**Notice of Allowability**

10/614,978

PULLEN ET AL.

### EXAMINER'S AMENDMENT

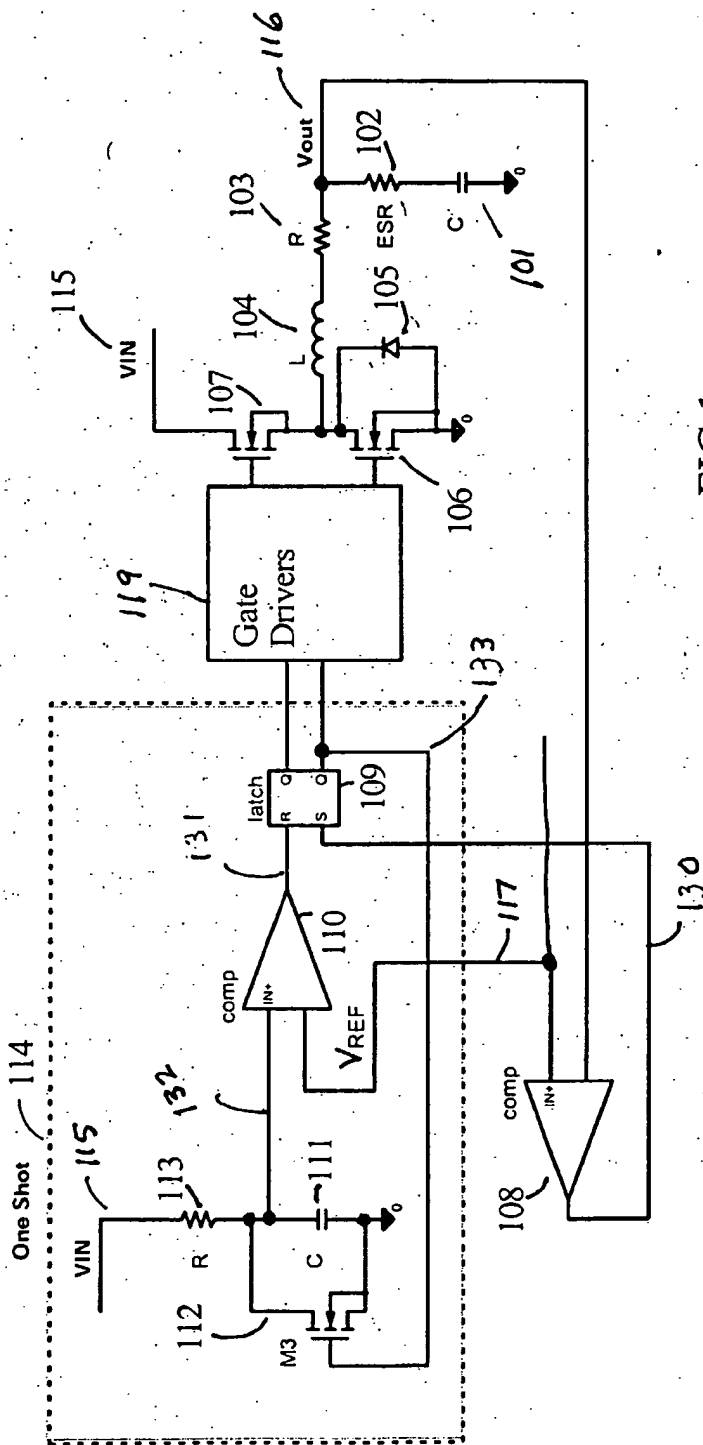
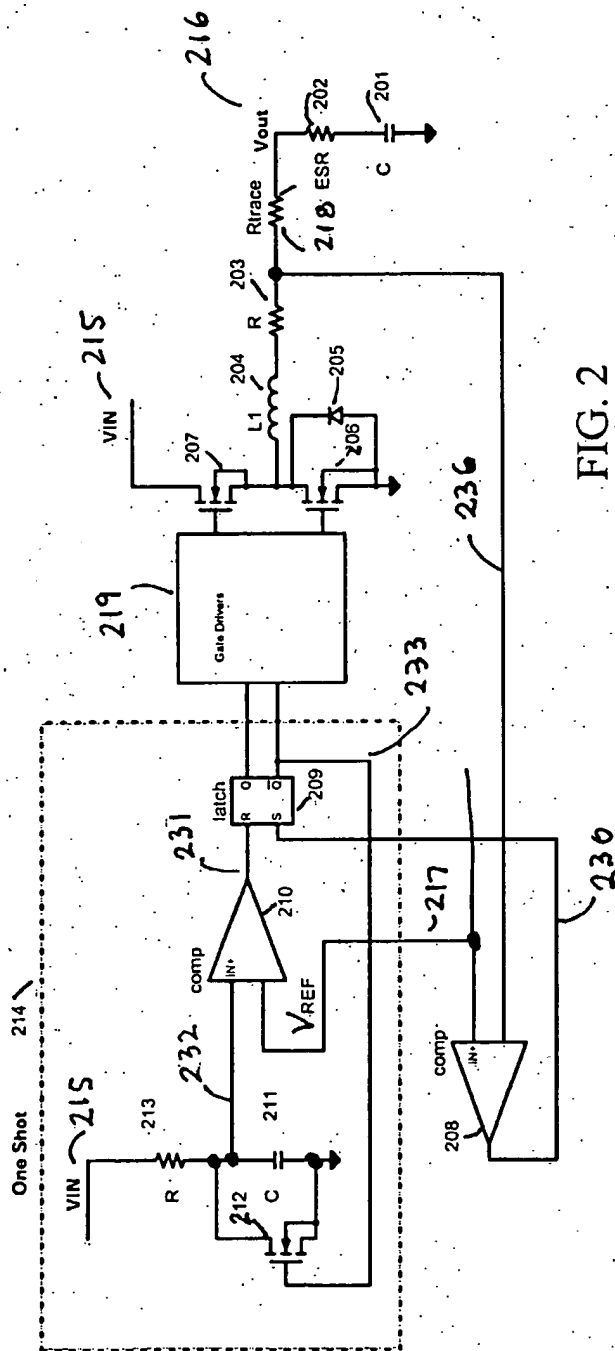
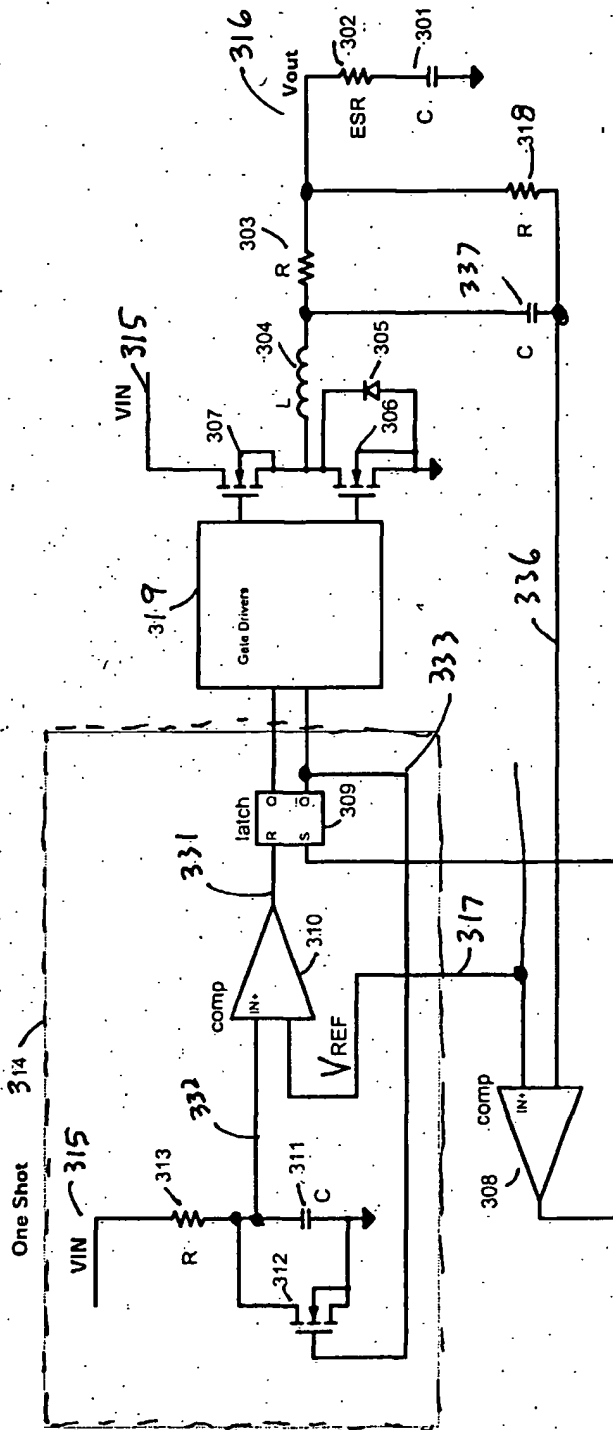
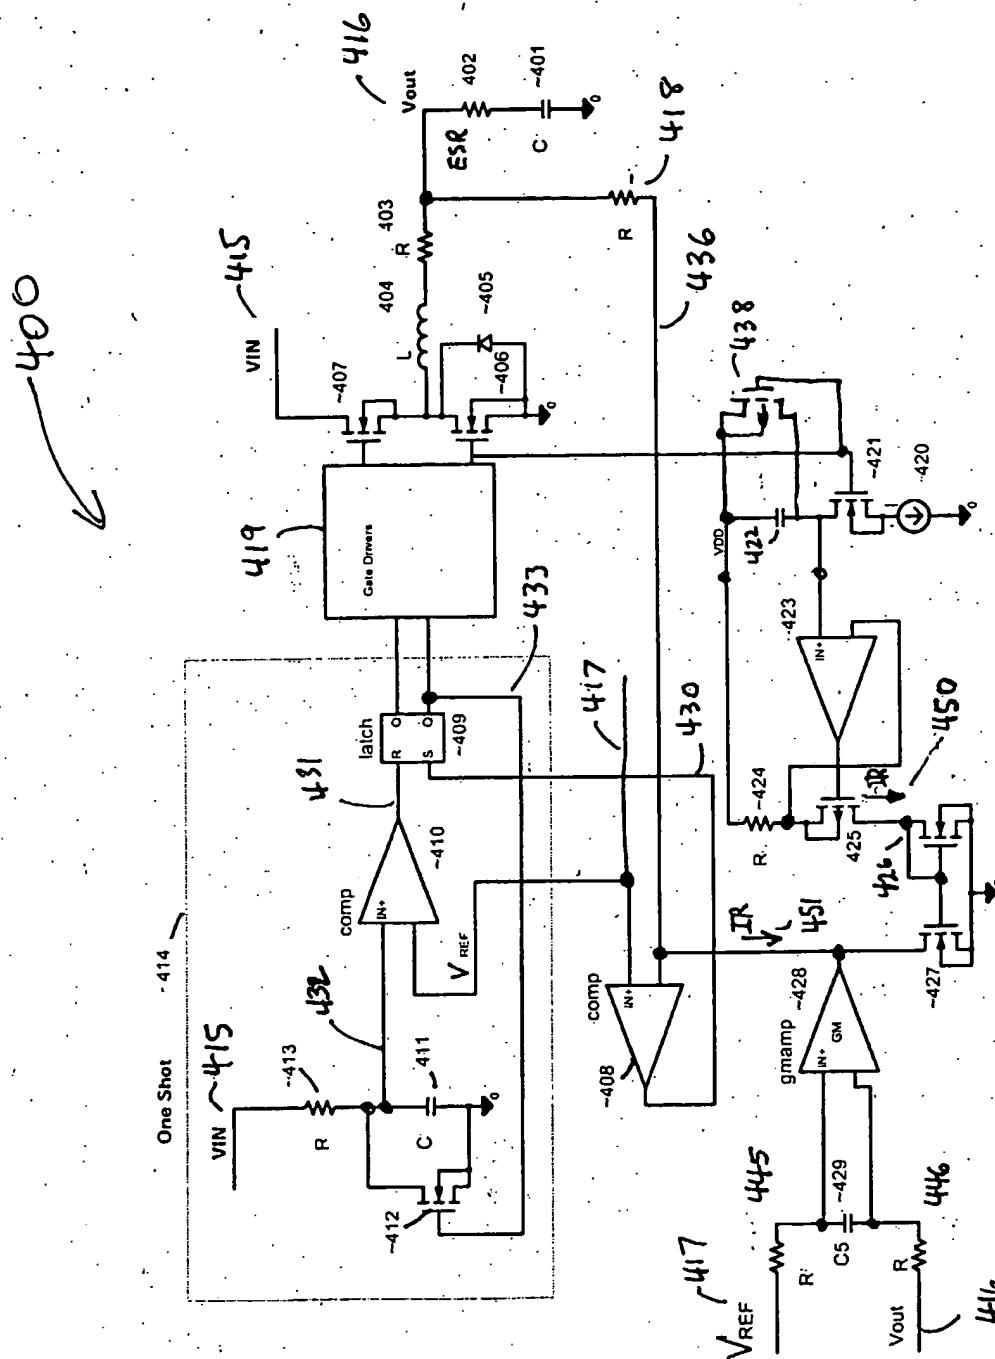
Note attached copies of the drawings corrected in red.
